ADDENDUM NUMBER 1

1.02 PROJECT: ERNEST KNIGHT LLC FIRE ALARM SYSTEM

1.03 PROJECT NUMBER: 26236.0 DCM/BC NO. 2023632

4.01 SHEET E0.1 – LEGEND, NOTES, DETAILS, AND RISER

RISER DIAGRAM FIRE ALARM SYSTEM

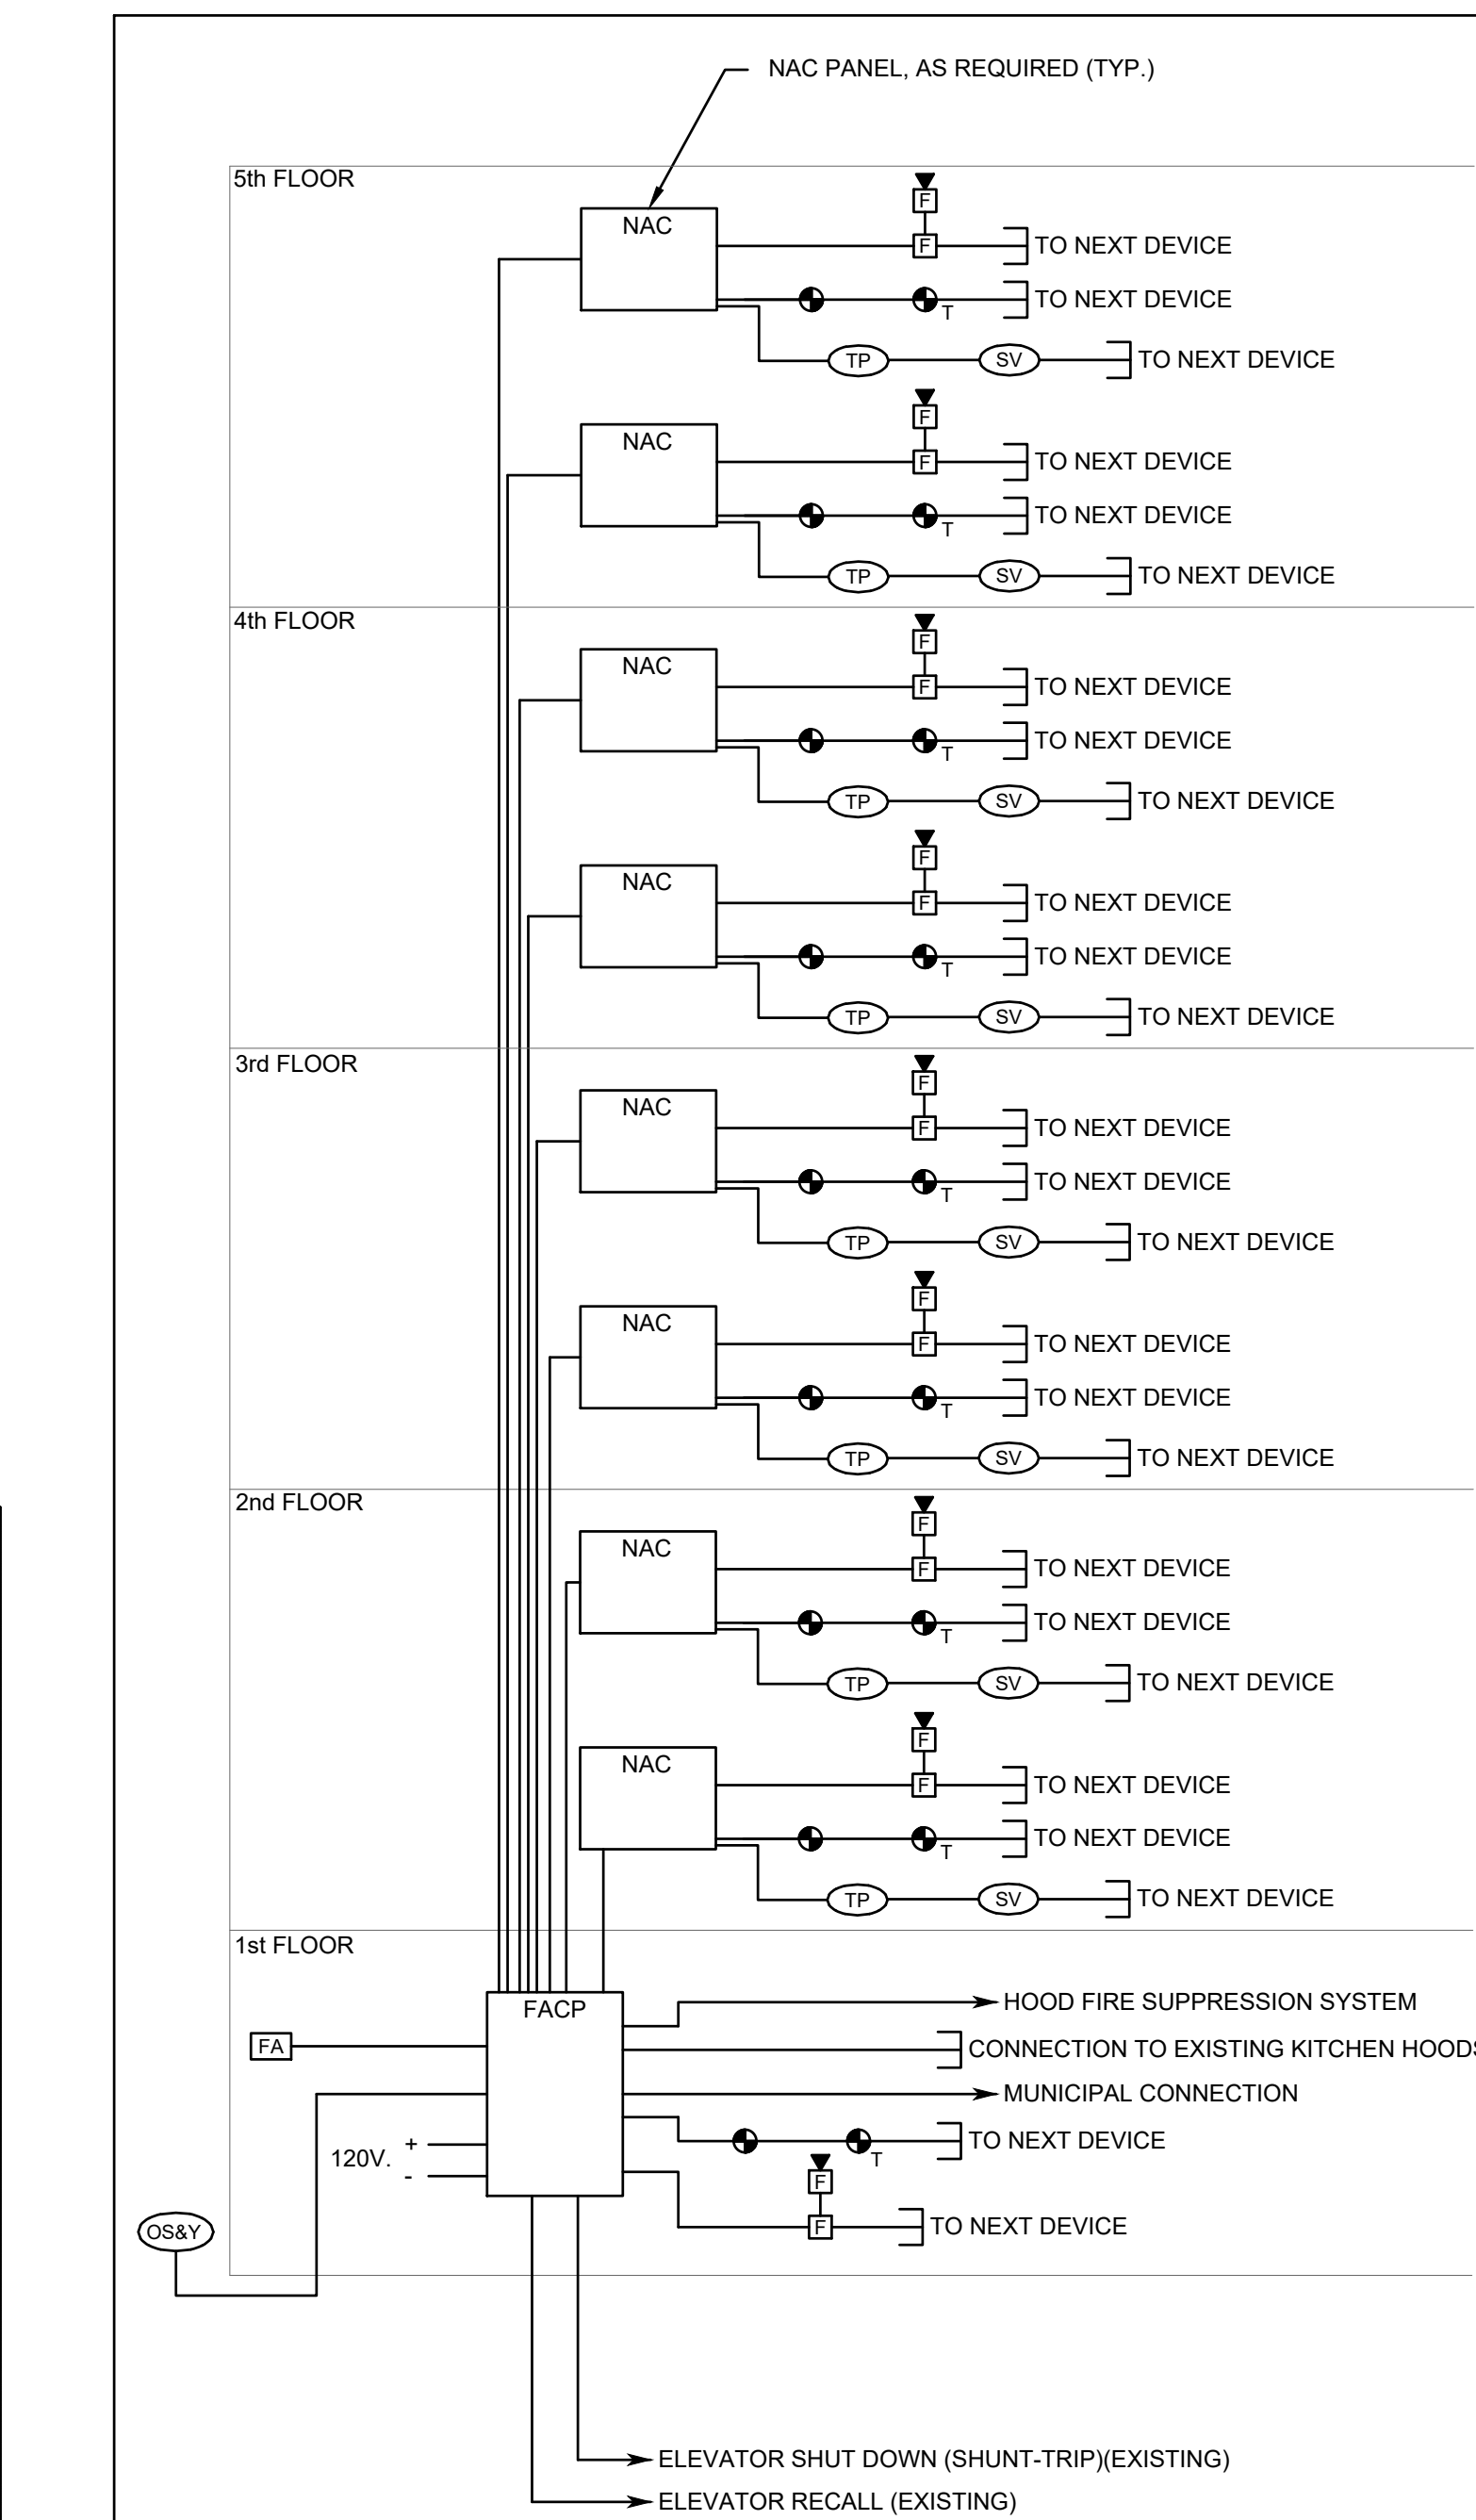
- A. Legend for dorm room devices updated.
- B. Special Construction Notes G and I updated.
- C. Fire Alarm Riser Notes 25, 26, and 27 added.

- ANY DETECTOR ACTIVATION IN EACH DORM SUITE WILL ACTIVATE ALL SOUNDEERS/SPEAKERS WITHIN THAT SUITE AND REPORT A SUPERVISORY SIGNAL TO THE MAIN PANEL.
- SOUNDEERS/SPEAKERS SHALL ACTIVATE DURING BUILDING GENERAL ALARM.

- WHEN A SMOKE WITHIN A DORM SUITE IS ACTIVATED, IT SHALL INITIATE A LOCAL ALARM WITHIN THE SUITE, AND NOTIFY THE FACP AND ANNUNCIATOR AS A SUPERVISORY CONDITION. IF 2 OR MORE SMOKES WITHIN ONE SUITE ACTIVATE, IT SHALL ALARM LOCALLY AND SET OFF ENTIRE FIRE ALARM SYSTEM AND TRANSMIT FIRE ALARM SIGNAL TO MONITORING COMPANY. SMOKE DETECTORS WITHIN SUITES SHALL BE INTERCONNECTED.
